Detailed Site Plan Melford Mansions

DSP-22043-03

REQUEST	STAFF RECOMMENDATION
Revise Condition 5 of the approved detailed site plan, to change the construction timing of the plaza amenity.	With the conditions recommended herein: •APPROVAL of Detailed Site Plan DSP-22043-03

SUBJECT: Detailed Site Plan DSP-22043-03
Melford Mansions

PUBLIC PLAZA

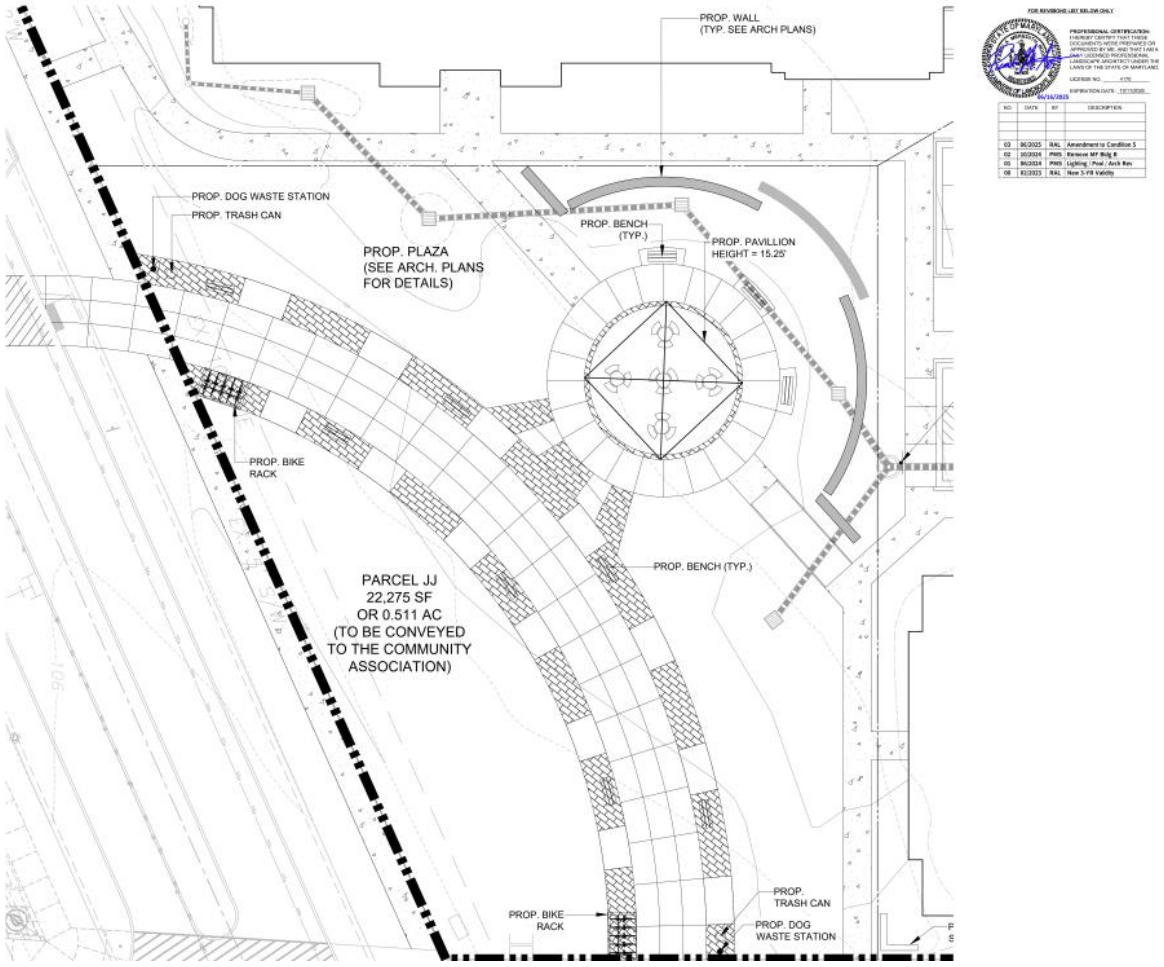
The approved public plaza, for which the change in construction timing is requested, features green space and a sitting area as a focal point and is located adjacent to the intersection of Curie Drive and Lake Melford Avenue. This public open space is complementary in character to the public plaza across Curie Drive to the west, that features an expanse of hardscape, as approved in DSP-18007.

Figure 1 shows the illustrative site layout of Melford Mansions, with building numbers labeled. The applicant seeks to first develop Buildings 1, 2, 6, and 7, which are the four buildings closest to Curie Drive, and to the recently completed Aspen multifamily building. Note that the plaza for which the change in construction timing is requested, is located adjacent to Buildings 6 and 7. The statement of justification (SOJ) states that the change in construction timing will eliminate challenges of public safety, construction, and financing that exist if the plaza has to be constrcted before the fourth residential building permit.

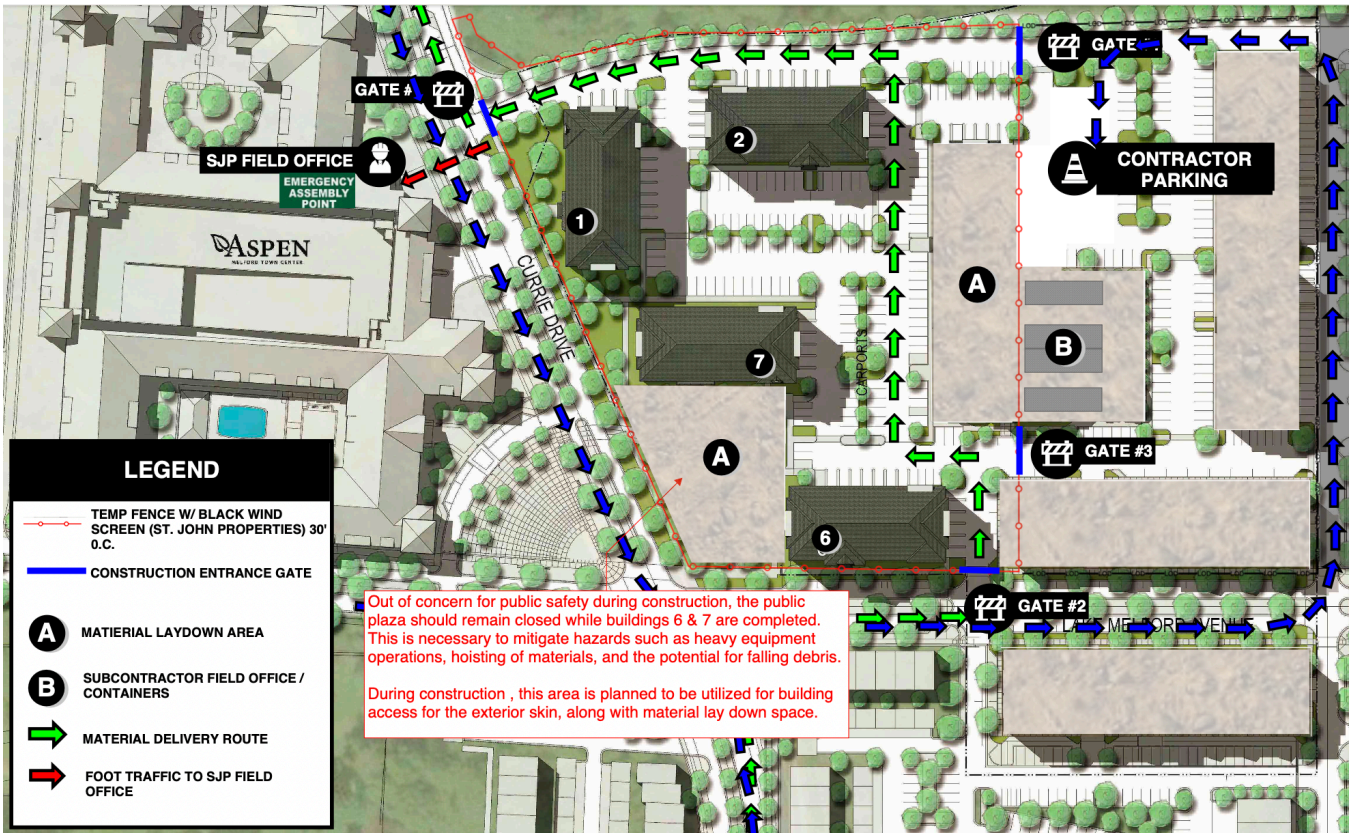
> **Public Safety** – Due to the proximity of portions of the plaza to buildings 6 & 7, it is important not to open any of the plaza to the public until all exterior work has been completed on these buildings. Maintaining adequate separation between construction activities and the public within the future plaza area is essential to protect public safety and to mitigate hazards such as heavy equipment operations, hoisting of materials, and the potential for falling debris during construction.
>
> **Constructability and Material Staging** – The plaza provides the only means of access for construction of portions of the exterior of Buildings 6 & 7. If the landscaping and hardscapes of the plaza are installed, we will no longer have access for the materials and equipment that will need to be installed on the exterior facades of these buildings. Additionally, this area is a prime laydown area for materials that will be used for construction of Buildings 1, 2, 6 & 7. The need to utilize the plaza area for construction purposes is more clearly shown on the logistics plan below (the area of the plaza is labeled "Material Laydown Area"):
